City of Richmond
Planning and Development Department

Report to Committee

To: Planning Committee
From: Brian J. Jackson, MCIP
Director of Development
Date: May 5, 2010
File: RZ 07-380222
Re: **Application by Onni 6951 Elmbridge Development Corp. for Rezoning at 6951 Elmbridge Way from Industrial Business Park (IB1) to Residential/Limited Commercial (RCL3)**

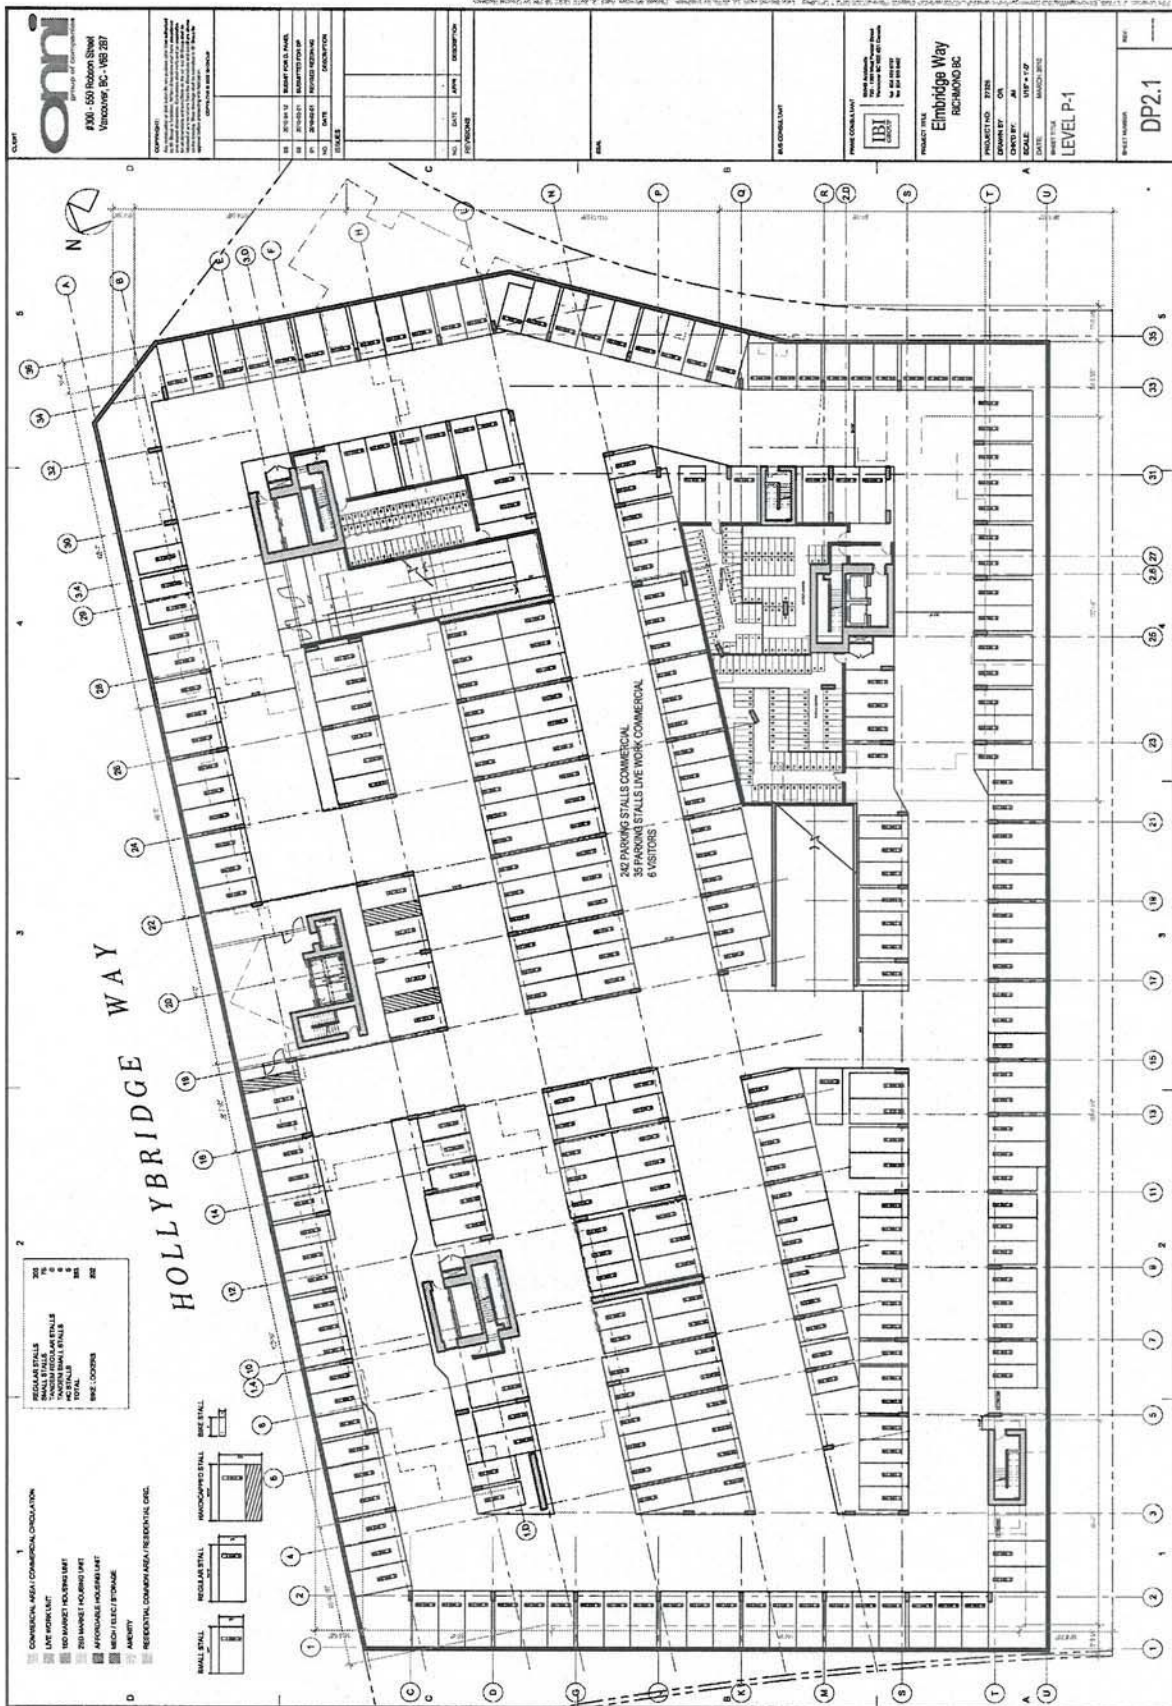
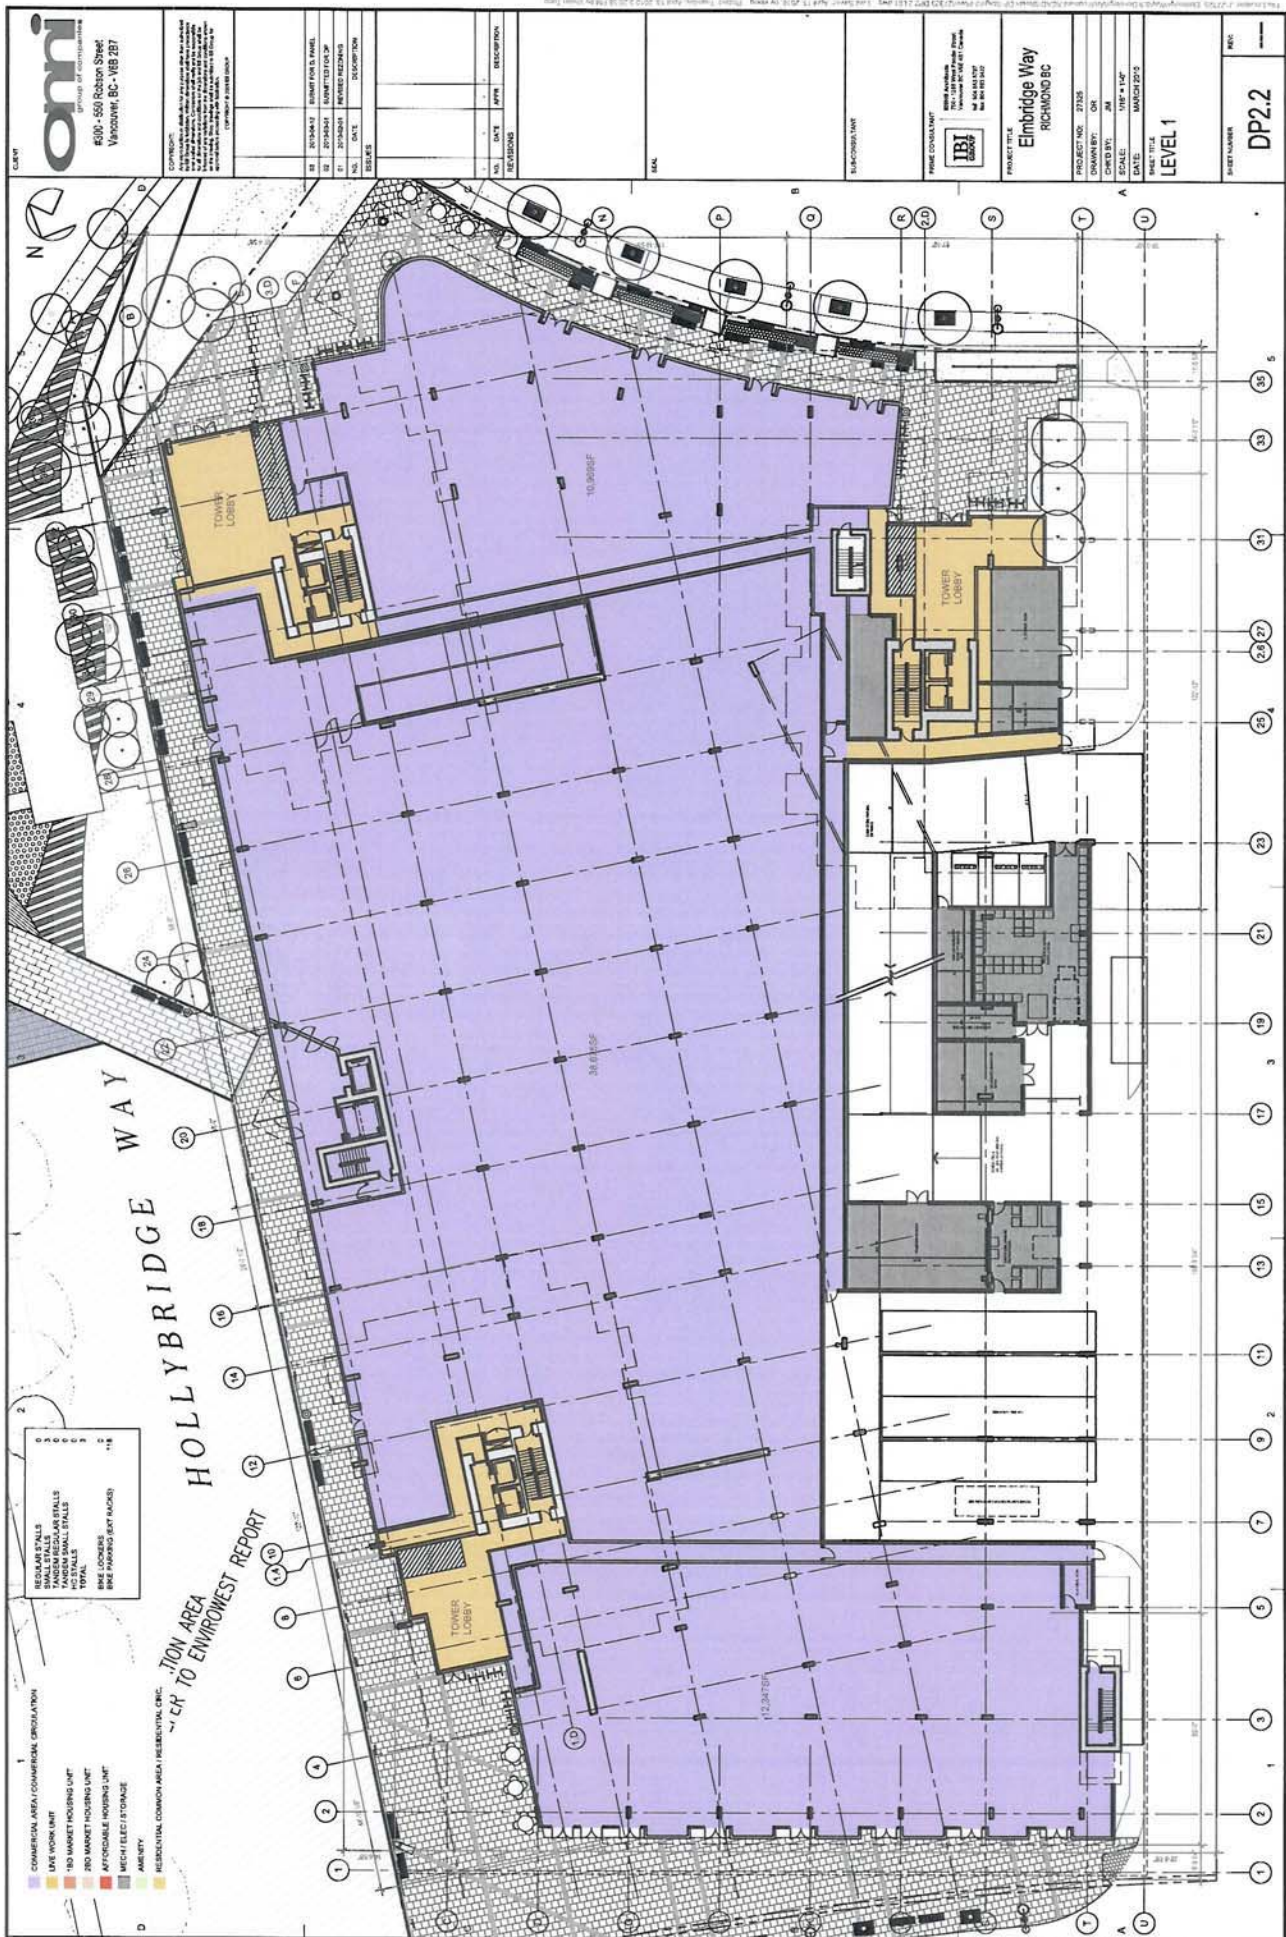
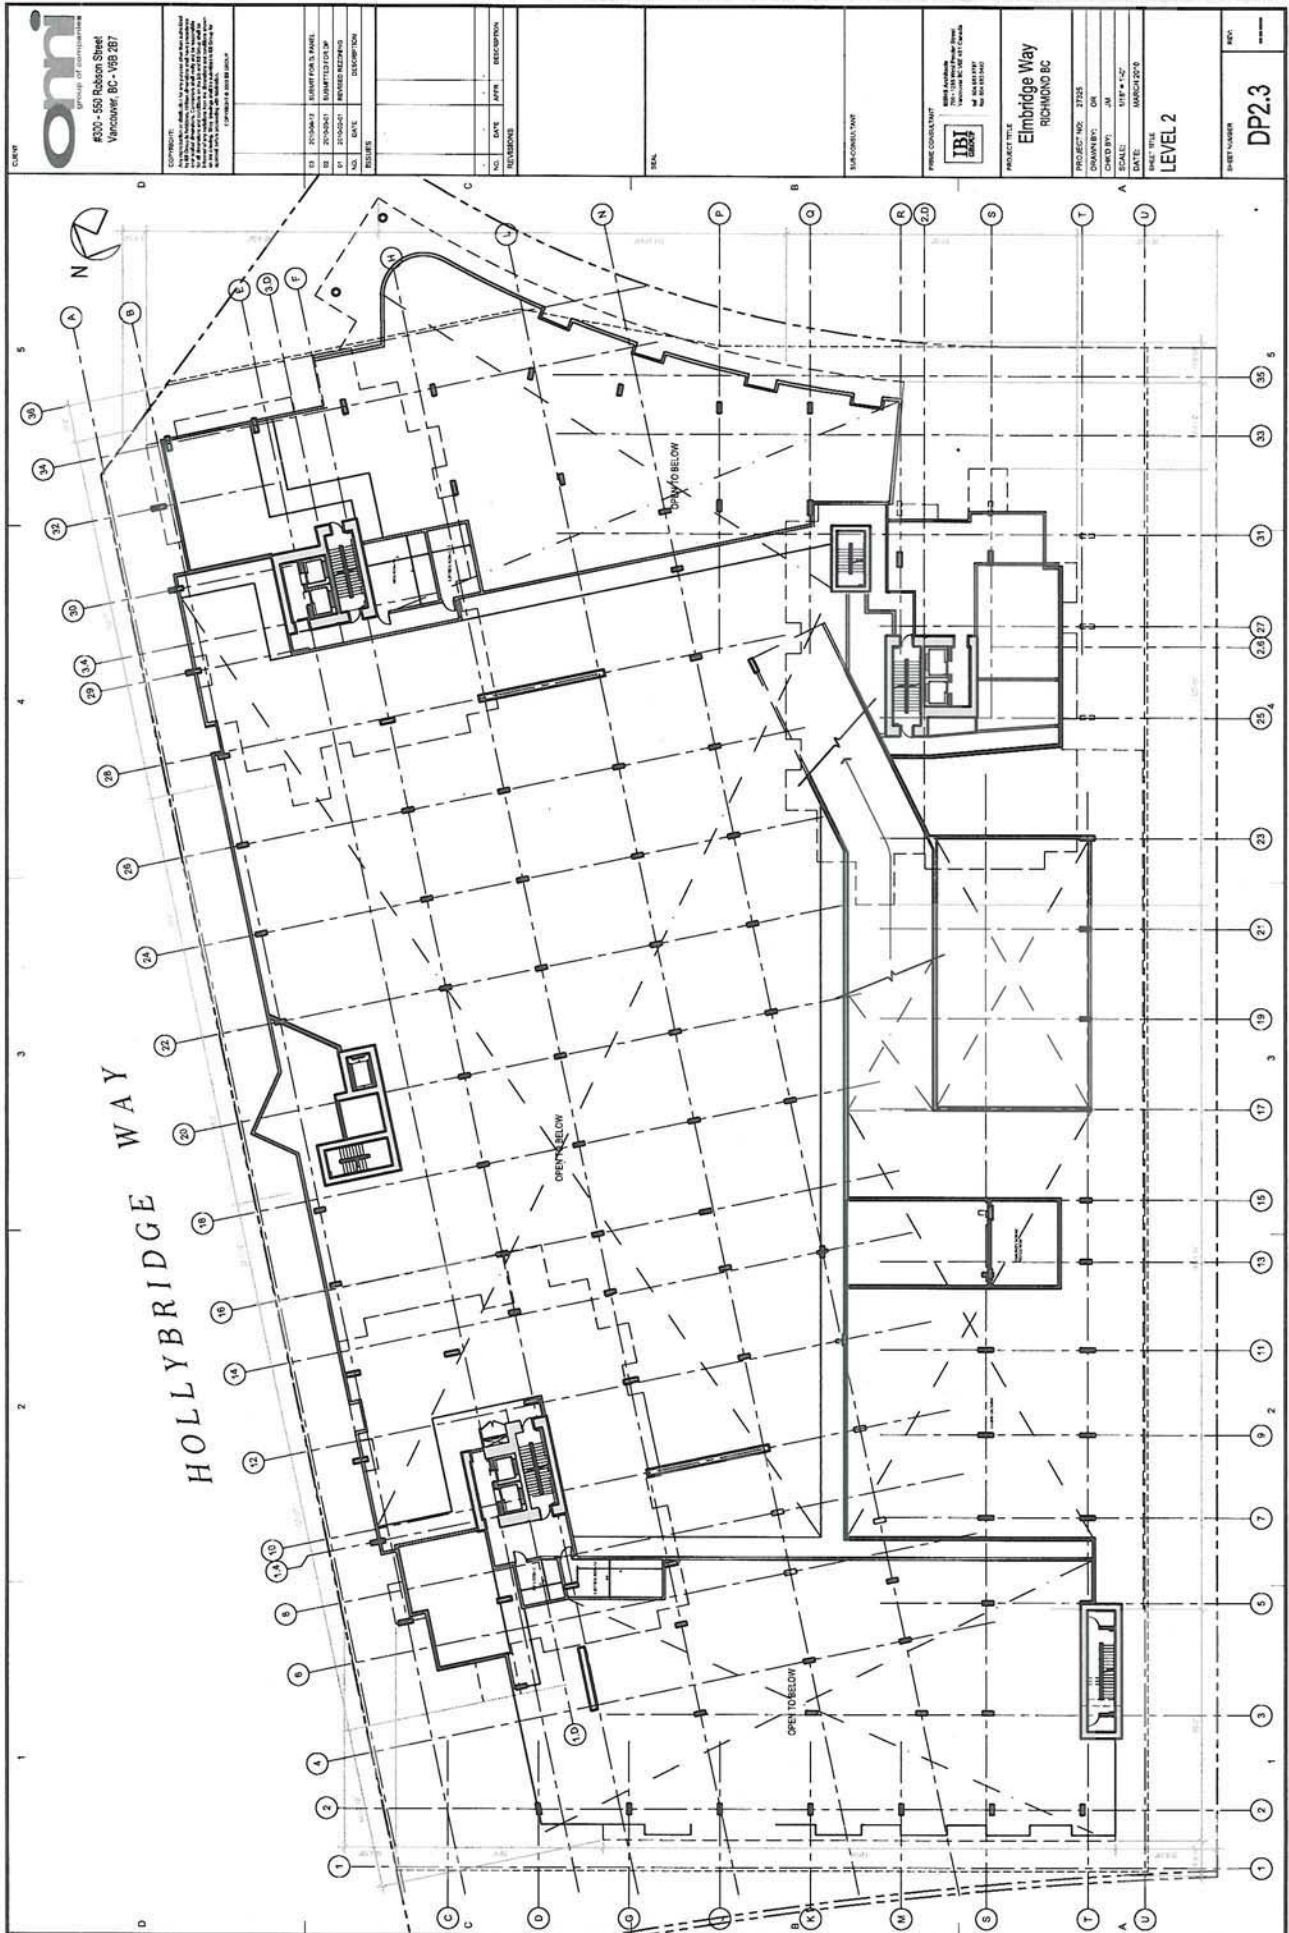
That the Advisory Design Panel supports RZ-07-380222 moving forward to the Planning Committee, taking into consideration the following:

- Examples:
- Review open space uses/activities to help create more liveliness at street level.
 - Create more interesting design elements along River Road.
 - Provide weather (sun, rain) protection along shop frontages and residential lobbies.
 - Re-orient the ramp adjacent to the proposed lane.

4. *design development to the towers including massing, differentiation, roof treatment, colours, materials and relationship to podium and ground plane;*

5. *design development to pedestrian connections and destinations in relationship to Lansdowne to provide a better understanding of context and connectivity;*

- Examples:
- The project is very good, but lacks the iconic/signature image befitting its location.
 - The terminus needs to be made a stronger focal point, with a distinct identity.
 - Terminus feature is "forced", raises structural issues, and does not tie into the project.

7. *design development to integrate signage opportunities;*

B. *The applicant taking into consideration the following comments:*

8. *consider programming of the outdoor spaces; and*

- Examples:
- Urban agriculture is good, but provide for more variety of rooftop open space uses.
 - Strengthen the functional/social relationship between indoor and outdoor amenities.
 - Consider edge treatment around garden plots to visually contain them.

9. *consider the potential integration of public art into the project.*
